ADDENDUM #1

PROJECT: Moving Montrose Forward Street Maintenance Project
BID NO: 22-007
FROM: Ryan Cushenan
DATE: 04/18/2022

CITY OF MONTROSE
MOVE MO
MONTROSE, CO
UNCOMPAHGRE AVE.
PLAN & PROFILE

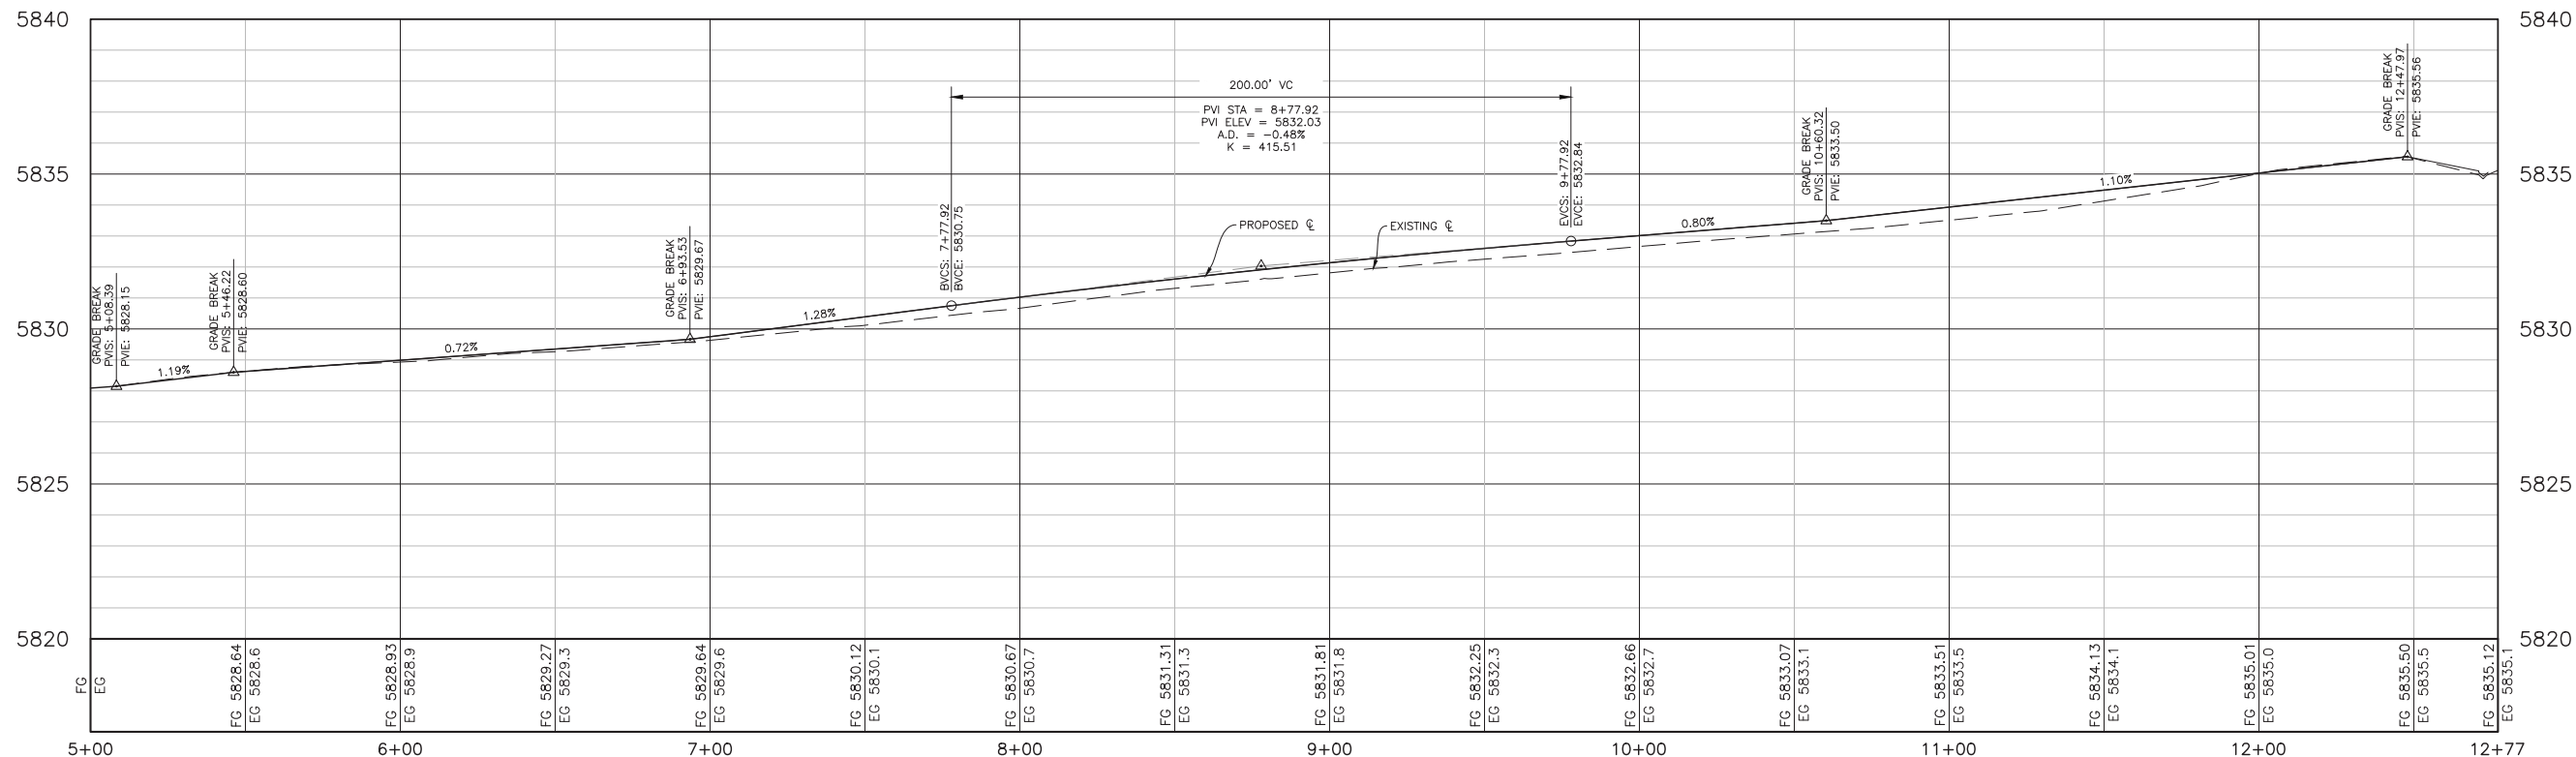
1. Appendix A, Sheets 1 and 7 have been updated to limit export from S Uncompahgre. See attached.

1. Exports from South Uncompahgre between S 7th and S 9th associated with Line Item 5, should be anticipated as less than 100 CY.
